File Number: ACS2017-PIE-RHU-0024

SUBJECT: Application for New Construction at 667 Bank Street, a property designated under Part V of the *Ontario Heritage Act* and located in the Clemow Estate East Heritage Conservation District

Figure 1

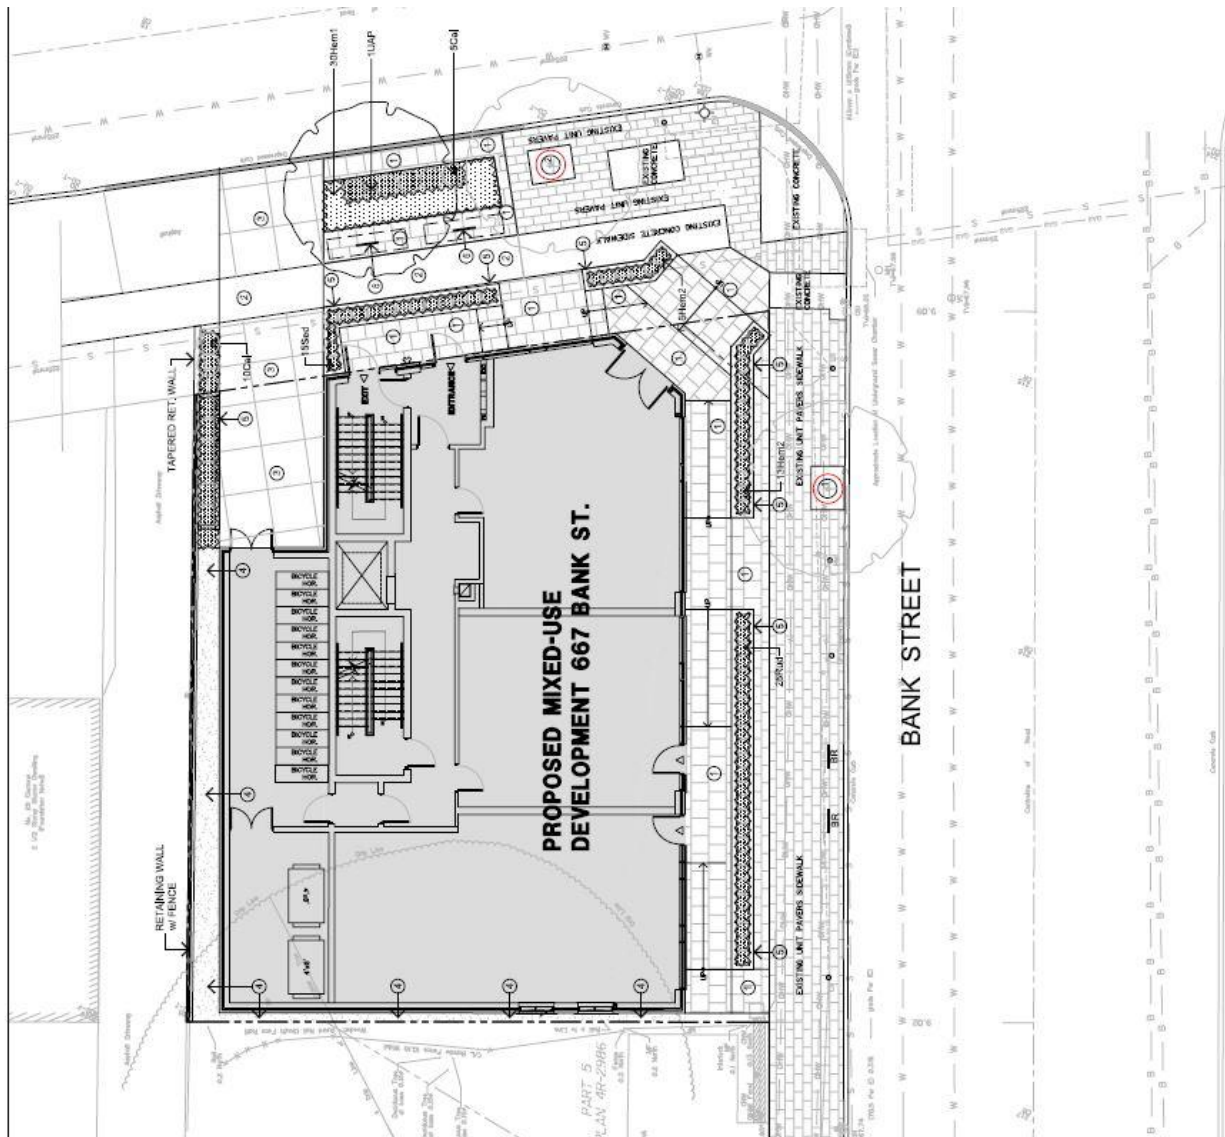
We had expressed concerns about previous versions of this proposal, including that the façade facing the adjacent house in the Heritage Conservation District was too high and too close. The current version has addressed this by eliminating units that were close to the rear lot line, so that there is now only a one-storey structure at the rear. The impact of this is also mitigated by having a green roof.

As we noted previously, the revisions made to the north façade are an improvement and more compatible with the park than the initial application. Although we had previously commented that the cornice line should be at the third rather than fourth levels, to be more compatible with the historical pattern of the streetscape, we do not consider this a very major issue.

North rendering, current version, showing removal of two storeys at east side

South rendering, current version, showing removal of two storeys at east side and new attached accessory building

Document 8 – Views along Clemow Avenue

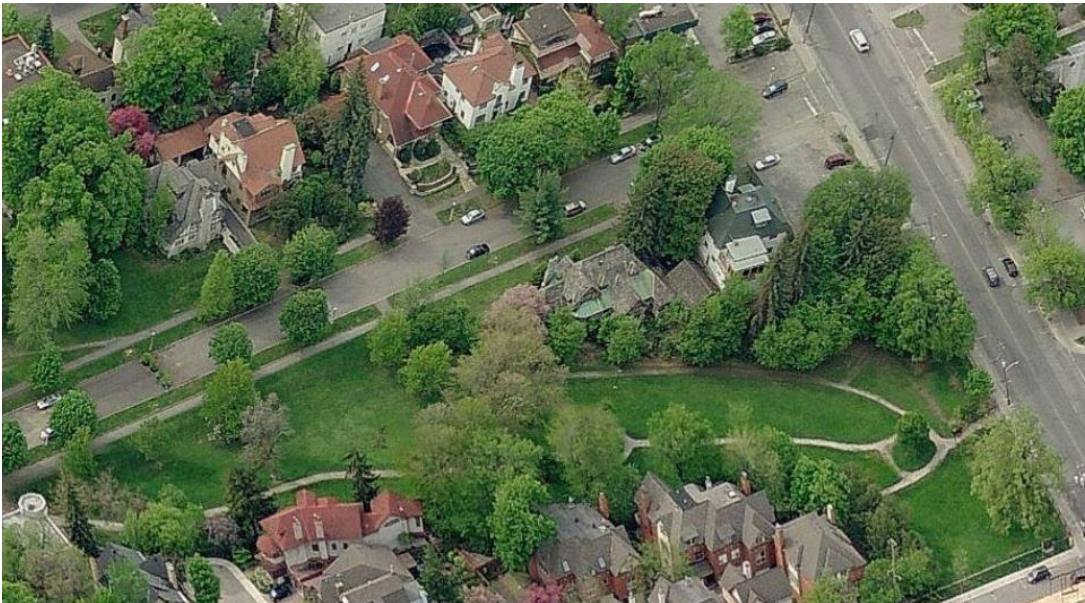
The east façade will be generally located where the white vehicle is parked. The corner will be landscaped to extend the boulevard to Bank Street.
